# Wylfa Newydd Project

## Horizon's Response to Written Representation - Natural Resources Wales

PINS Reference Number: EN010007

18 December 2018

Figure 2-4 Mound A (Western Side): Drainage Schematic Diagram

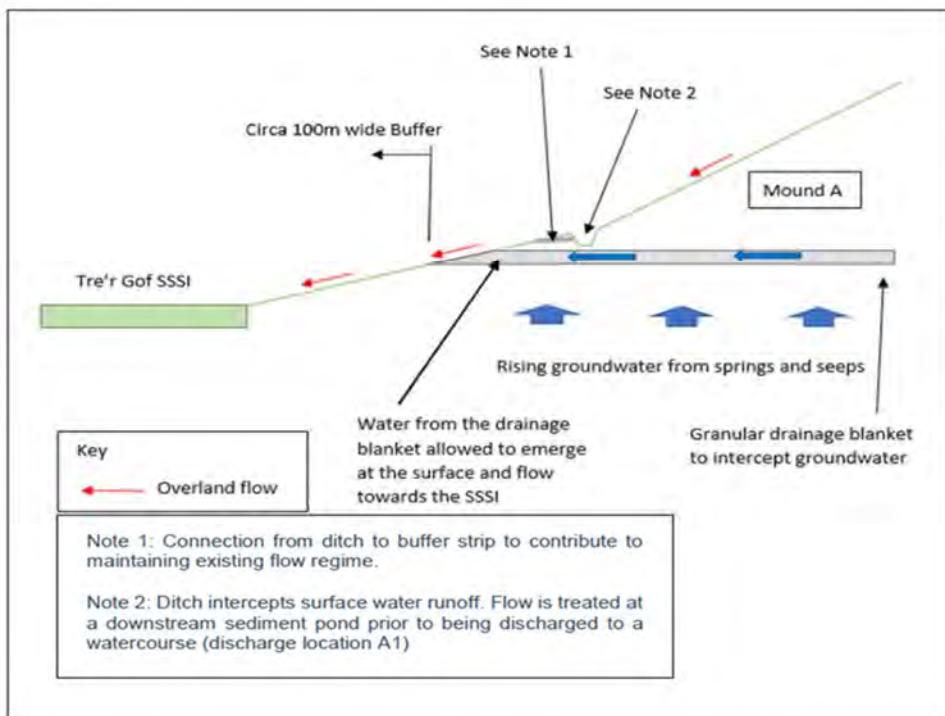
7.54.5 The schematic diagram presented in figure 2-4 (reproduced below) illustrates how, as far as practicable, the existing flow regime will be maintained.

7.54.6 The bulk earthworks for Mound A including thickness and location of the blanket will be designed in detail and executed in conjunction with other processes including, but not limited to, surface and subsurface drainage works and environmental control measures. Current thinking is that the drainage blanket would be continued beneath the drainage ditch so that water can seep from the base of the drainage ditch into the drainage blanket and move towards the Tre'r Gof SSSI. Horizon acknowledges that the drainage blanket will not be fully flexible once emplaced under the mound. However, within the constraints of the current and future topography, there will be some flexibility on the relationship of the drainage blanket to the surface drainage system close to Tre'r Gof as part of the adaptive mitigation system being developed to avoid and reduce negative effects on the SSSI.

Figure 165: Suspended solids concentration ( $\text{kg}/\text{m}^3$ ) an hour after the final dredge: Mid depth.

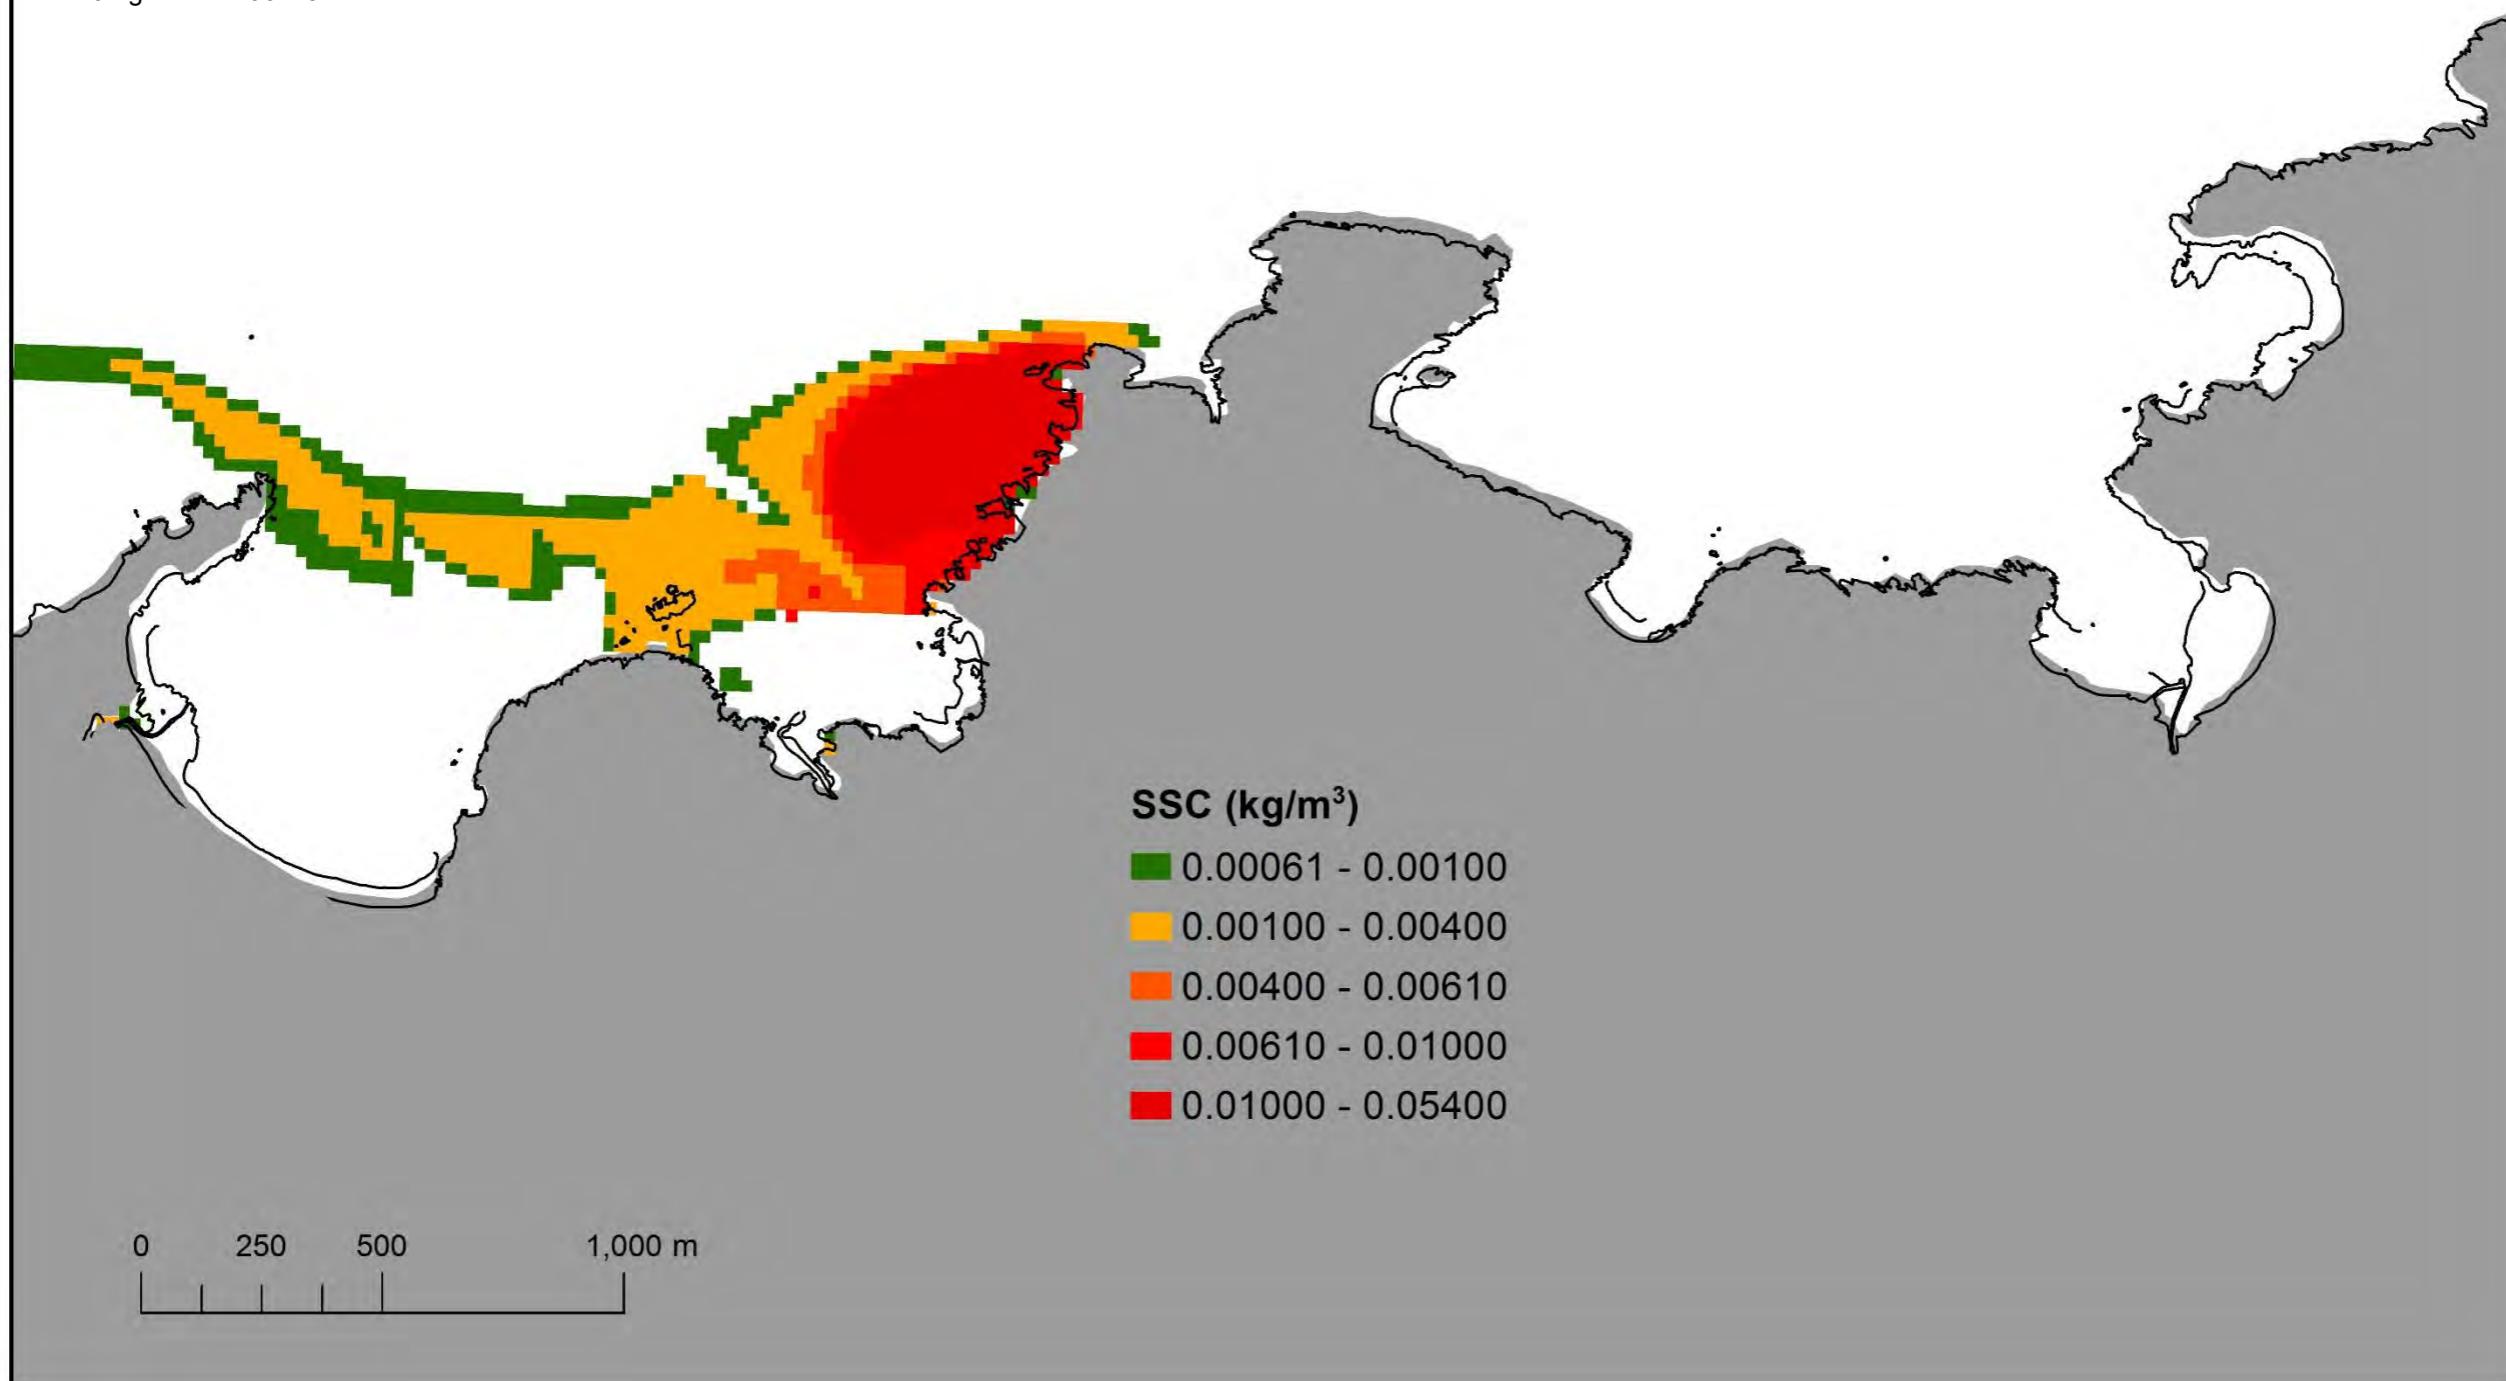
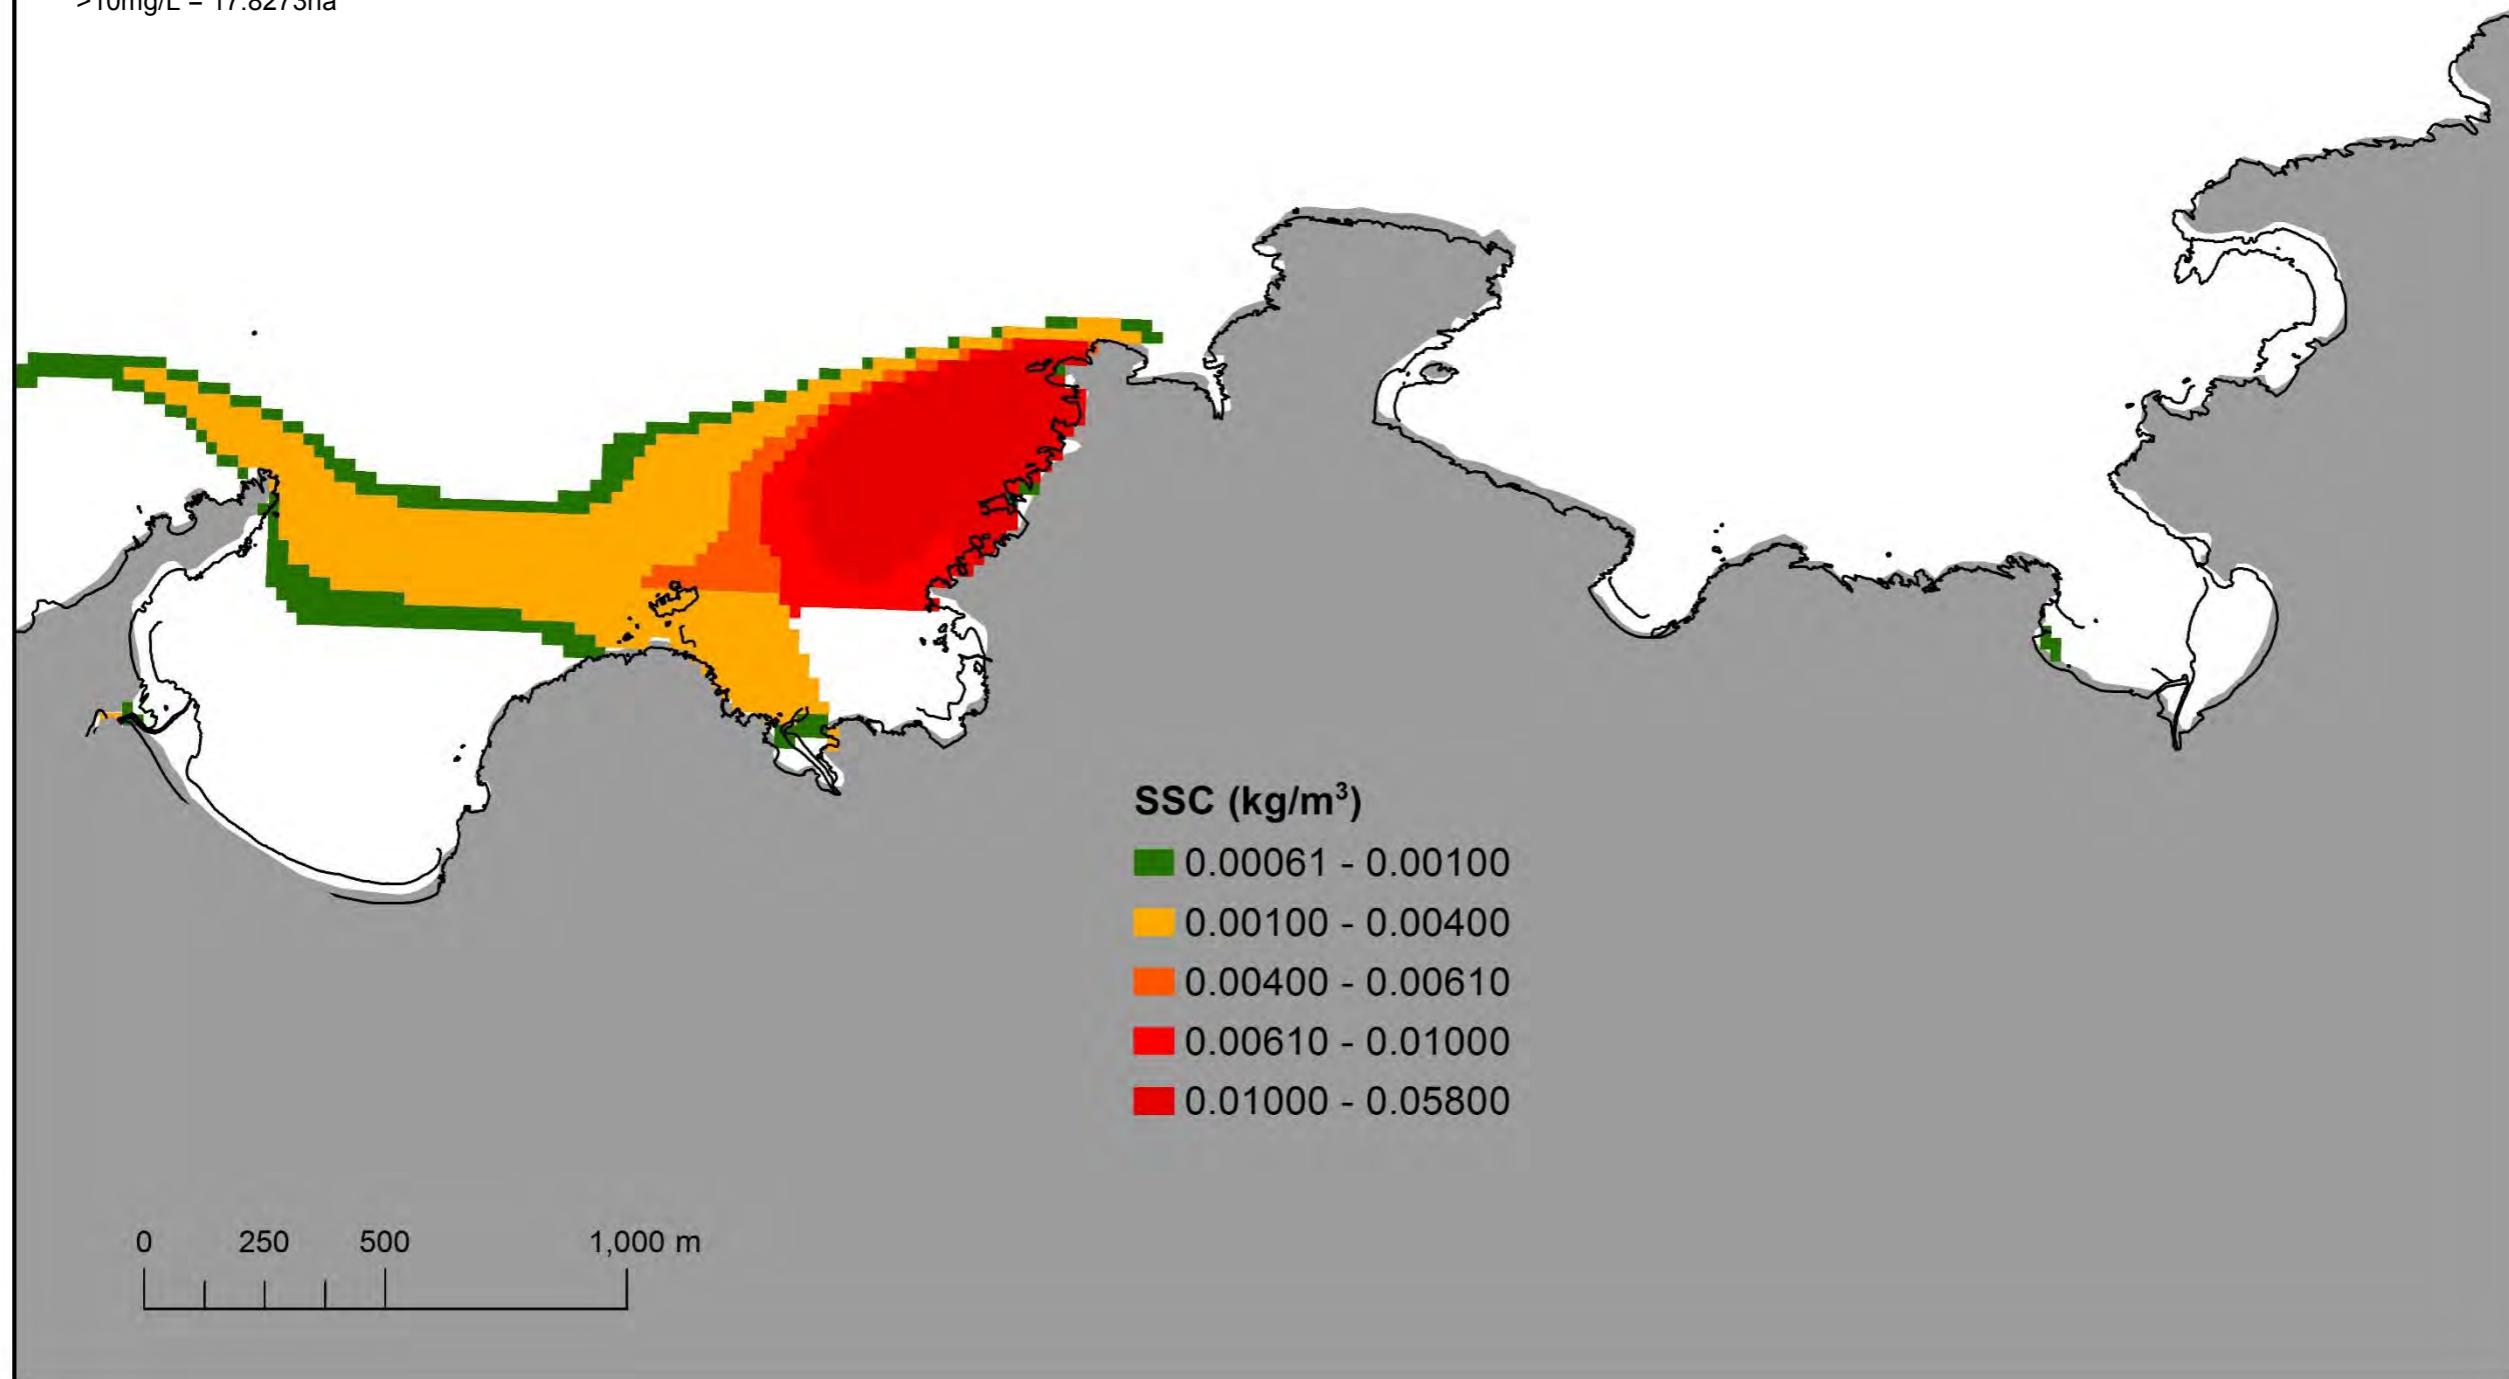
7.30.21 As agreed with NRW in the context of discussions regarding the Environmental Permit application, Horizon has prepared revised figures and recalculated the areal extent of change above a 10% background (0.61mg/L total suspended solids loading) as agreed. This data is provided in Appendix A to this document. The total suspended solid plots presented in figures 164; 165; 166; 169 & 170 in appendix D13.08 [APP-226] show the increase in suspended solid concentrations for the Wylfa Newydd DCO Project. These plots have been updated in Appendix A to show suspended solid increases above 10% of background (i.e. >0.61 mg/L total suspended solids) and areal extent.
